TO: Al Martin
City of Madison
Urban Design CommissionFROM: Bruce Simonson
Simonson Germany Nonemaker + AssociatesRE: Midvale Plaza Redevelopment
Initial Exterior Design Approval – July 12, 2006

Midvale Plaza Redevelopment

A Mixed Use Project at 505-550 Midvale Blvd.
Madison, Wisconsin

Midvale Elevation

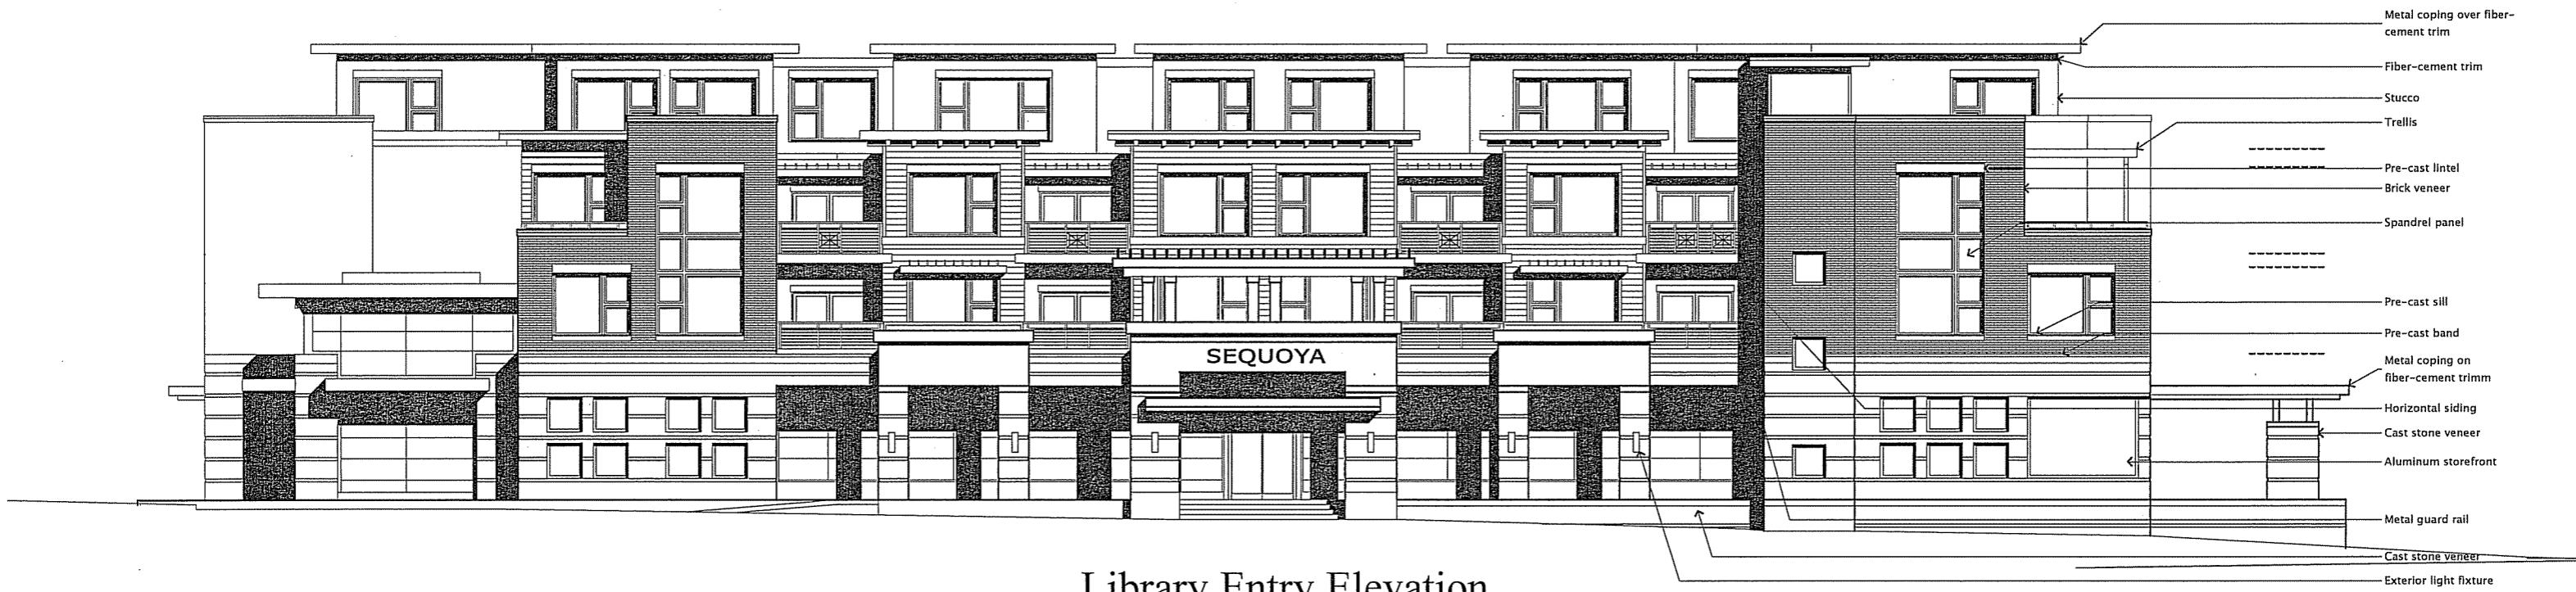
1. The base material for the library will be a cast stone or brick material that will separate it visually from the retail portion of the building.
2. The library will include glazing and window patterns that are distinct from the retail and residential portion of the building.

3. The material palette for the building will be simplified by having all three story portions of the building at the street plane be brick as opposed to a combination of brick and siding. Siding will be used only on those portions of the building that are setback from the main facades.

4. At the residential levels we are proposing to use a window type that is more common to the area. A picture window with a single hung side lite.
5. The cornice details have been simplified. The brick cornice will be a simple cap. At the siding portions of the building the cornice will be lighter and more simply detailed.

6. The color scheme will also be simplified. A maximum of two brick colors and two siding colors will be used.
